RESPONSES TO BNL QUESTIONS ON THE
RELEASE AND CONSEQUENCE ANALYSIS
REPORTED IN THE BIG ROCK POINT PRA

CONSUMERS POWER COMPANY

July 29, 1982

Fig. 2 Extent of Thermal Attack as a Function of Time

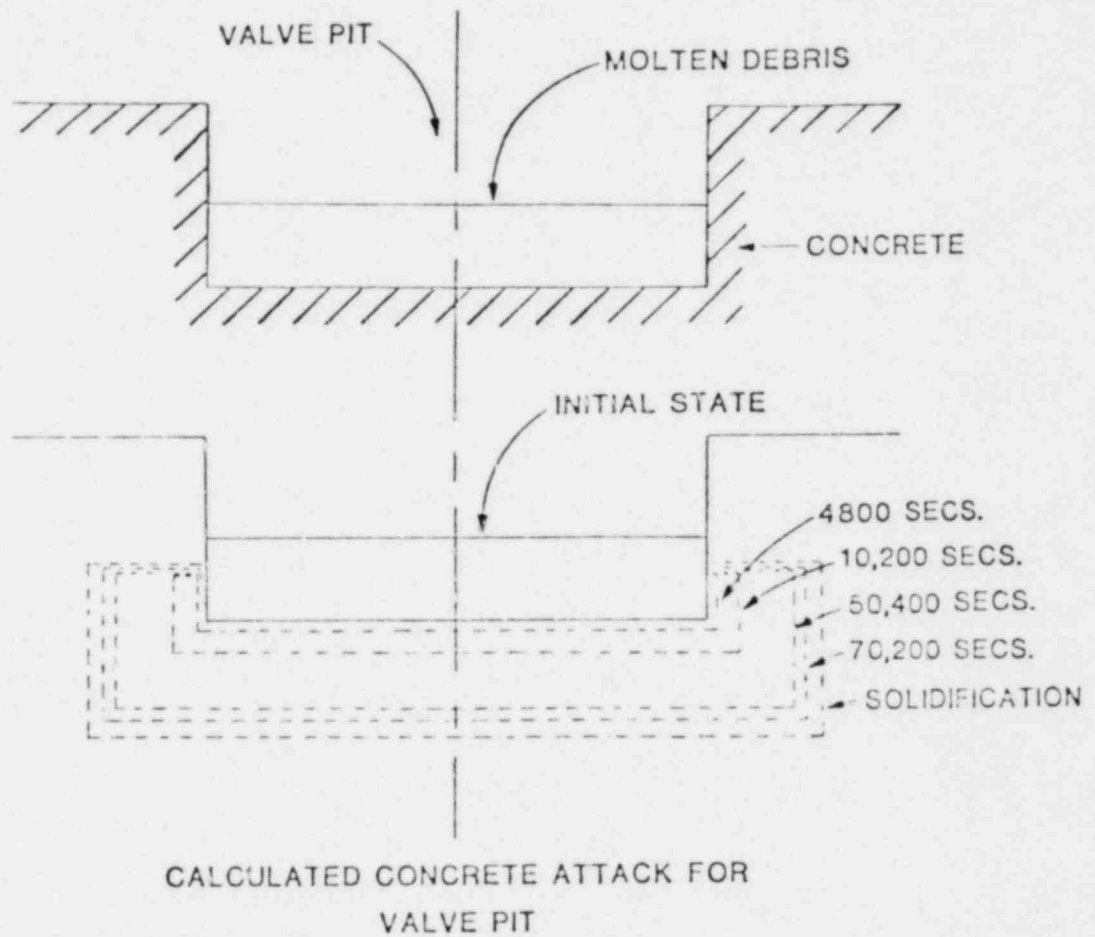
COMMENT 3.2.9 The failure of the basemat due to a core melt-through has been omitted based on mechanistic grounds. However, in the event that such an event should occur, methods of interdicting the contamination should be discussed. The discussion should include the rock formations into which the contamination would deposit itself and the possible ground water pathways available for transporting it.

The overall progression of the core debris is depicted in Fig. 2 showing the general outlines of the molten mass as a function of time and also indicating the final position where solidification occurred. As illustrated, the original attack is rapid but quickly decays and equilibrates to a frozen condition after 102,600 sec (28.5 hrs) with 0.53 m of downward attack. The hydrogen evolved by this process can be determined from the water released from the concrete and results in an accumulation within the containment of $\sim 3\%$. Since the material available for oxidation during this concrete attack is generally the unreacted zircaloy from the in-vessel processes, the hydrogen accumulation within the containment would generally be less than 7%, i.e. less

than the global combustion limit. If additional metal is provided by melting of steel components inside of the reactor pressure vessel, the pressure vessel wall, or additional steel from the components within the valve pit, the reaction would be limited by the extent of concrete attack as considered herein. In addition, as the melt becomes more viscous, gases released from the concrete will begin to bypass the melt and not oxidize metallic constituents. This bypass was neglected in the above analysis, a conservative feature of the approach. In summary, the maximum extent of hydrogen generation including the in-vessel production and that resulting from a non-coolable debris bed assumption is equal or less than oxidation of all the zircaloy within the core.

As a result, the assessment made in the Big Rock Point Probabilistic Risk Assessment is not sensitive to the assumption of a permanently coolable debris bed and could withstand substantial concrete attack without resulting in additional risk to containment failure and public health and safety. This analysis has employed various assumptions, some very conservative and others somewhat optimistic, but the combination of the two provides a reasonable assessment of concrete thermal attack for PRA assessments.
